From: Adrian Salt And Pang
Sent: 02 August 2021 20:24
To: Josh Lawlor; Planning
Cc: 'Rad Neighbours'
Subject: 2021/1358/P No. 28 Avenue Road - Comments on Arboriculture / Landscaping proposals

**Planning Application,
Proposed Development at 28 Avenue Rd,
NW8 6BU
Application ref: 2021/1358P**

Arboricultural Review of Submission

Fig.2 Tree Plan for 1 Radlett Place and Landmark Tree Survey Omissions Application Number 2021/1358P

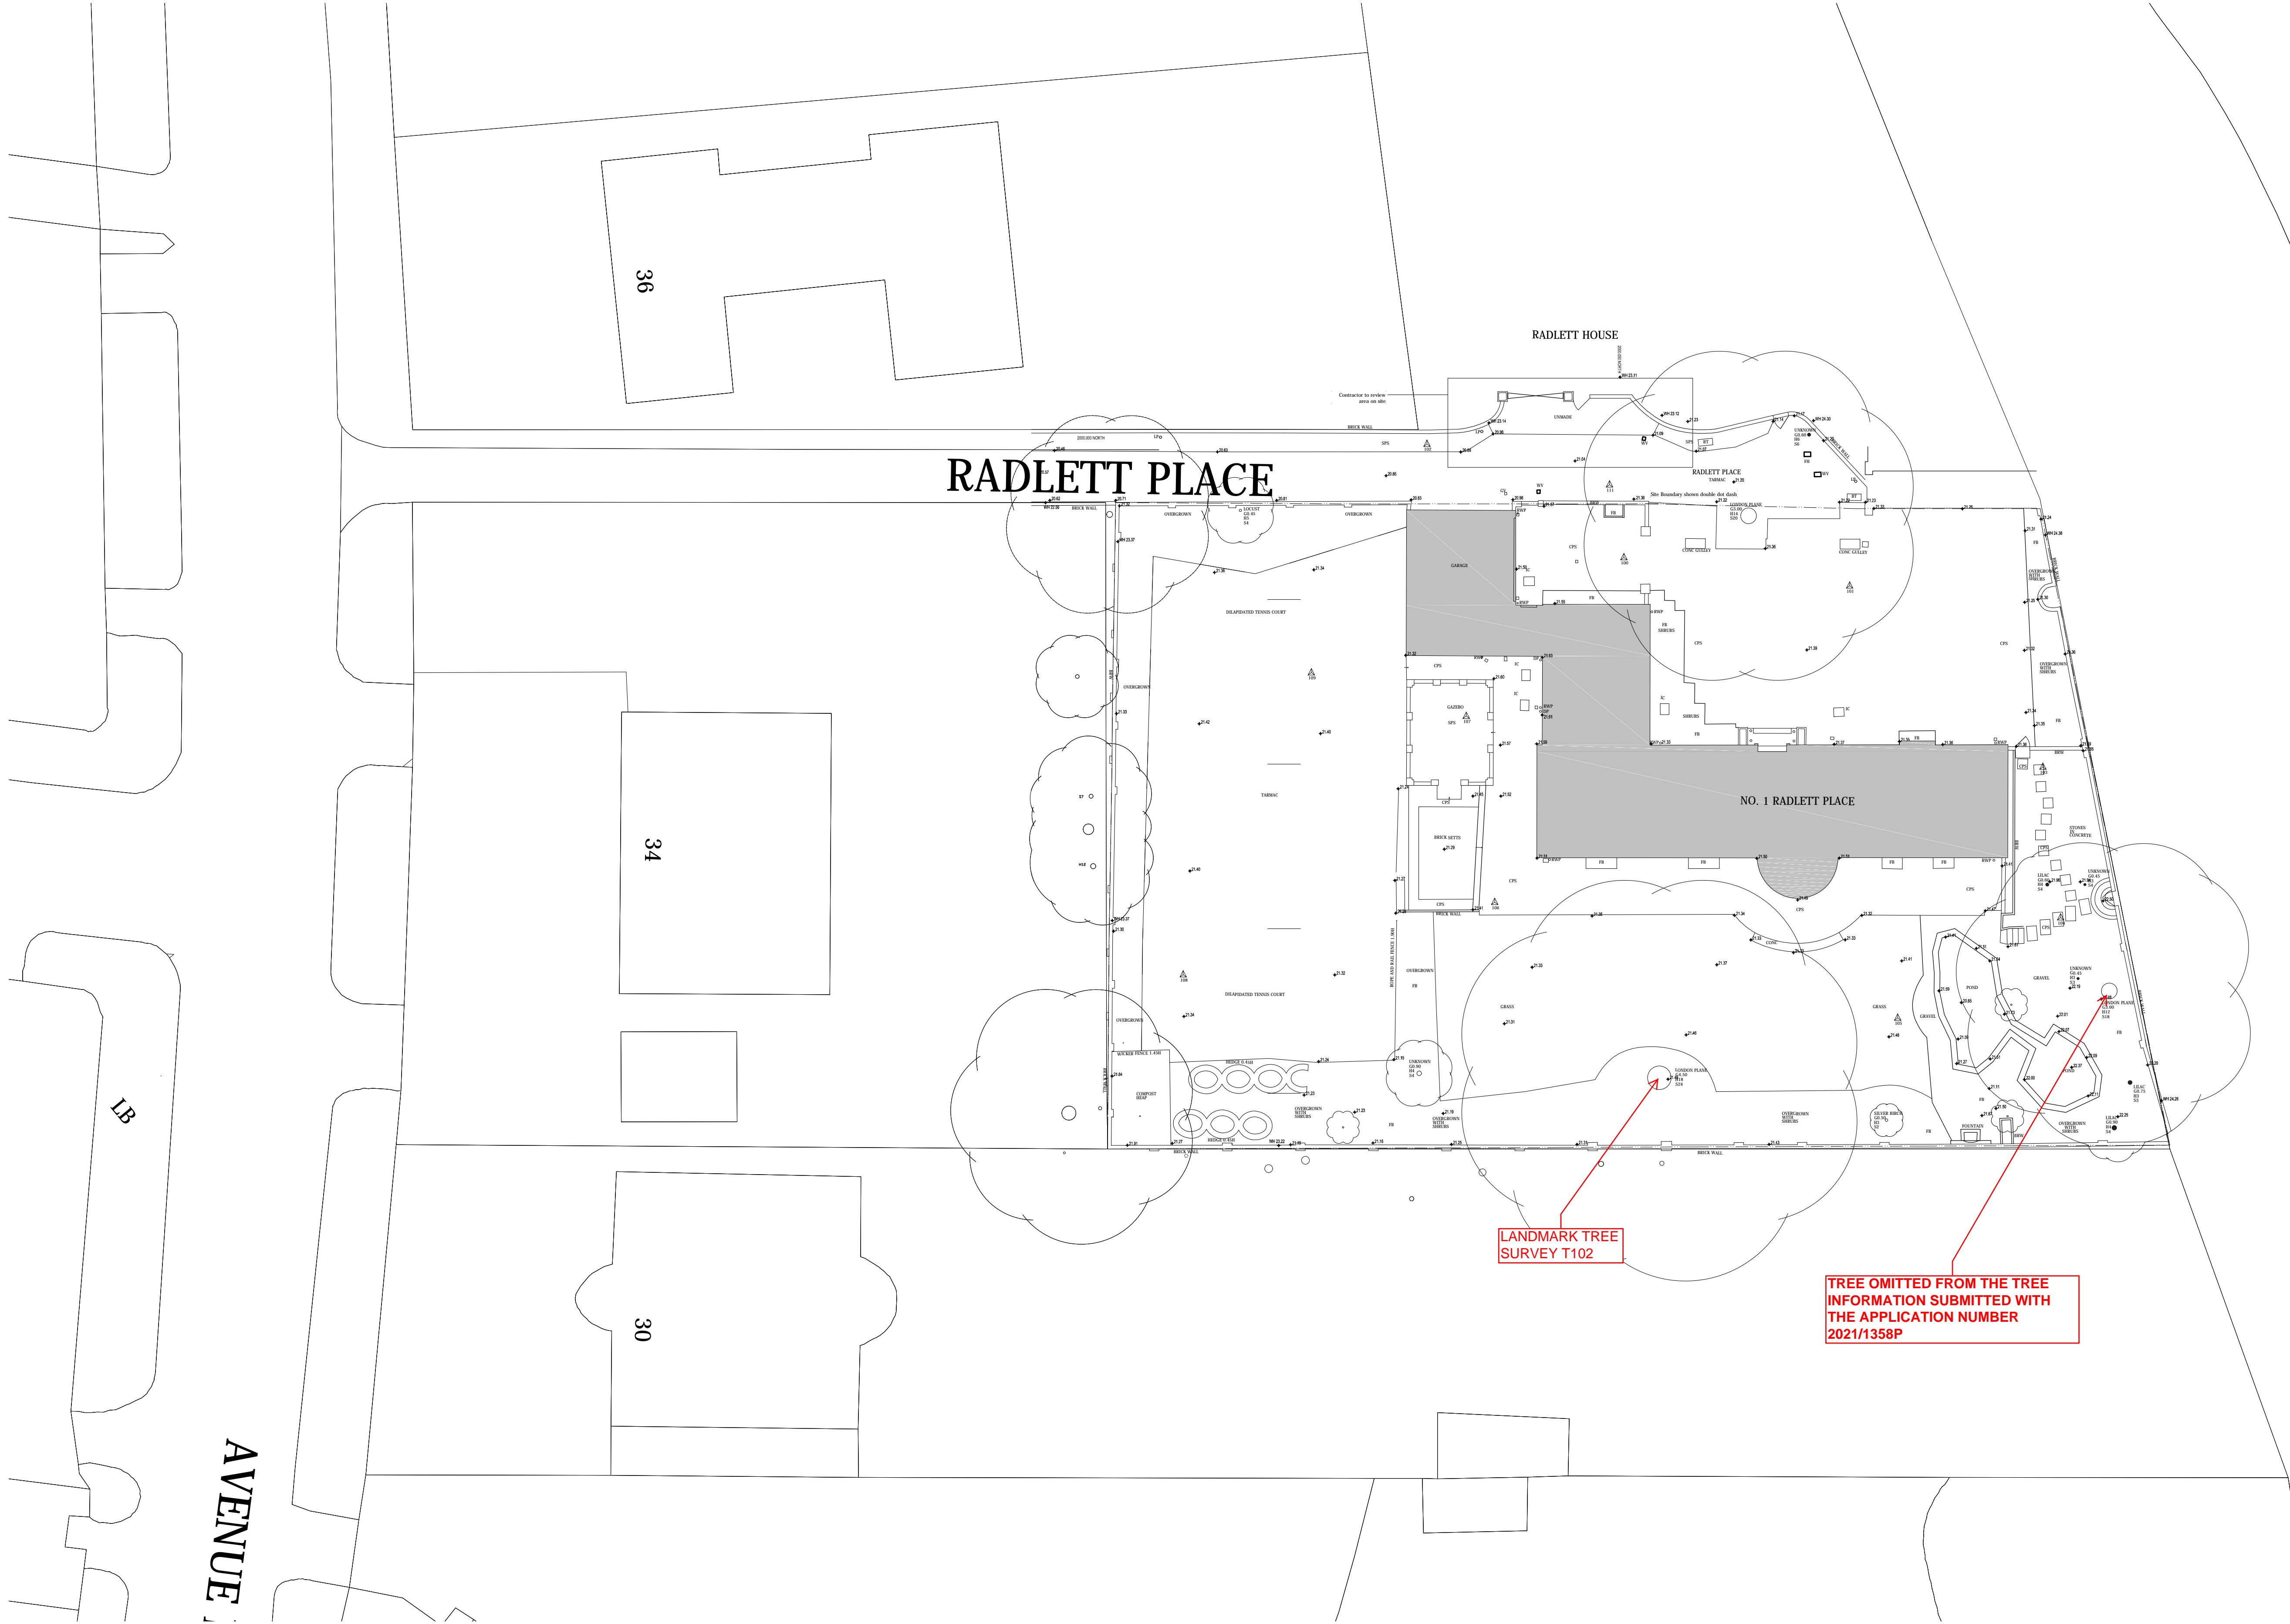
- 2.2 The tree survey data appears to be accurate, although it has not been possible to check tree dimensions on site. A substantial London Plane to the north west of the proposed pool has been omitted from the survey (refer to Fig.2 Tree Plan for 1 Radlett Place and Landmark Tree Survey Omissions Application Number 2021/1358P).

There are two mature London Plane trees in 1 Radlett Place which could be impacted by the proposed development. T102 on the Landmark Trees drawing is shown in the attached plan OSEL Drawing (700) 002, which shows the position of trees in 2013.

- The tree's omitted from the survey should be added (see annotated drawing at appendix 2.
- Data regarding trees off-site should be acquired and used in the arboricultural assessments.
- A co-ordinated approach to include trees in 1 Radlett Place should be adopted in any revised arboricultural assessments.
- The apparent discrepancy in tree locations should be resolved.
- A more detailed arboricultural impact assessment should be carried out, based on additional and revised tree location information.
- An arboricultural method statement should be required.
- A planting scheme should be required to mitigate tree losses.
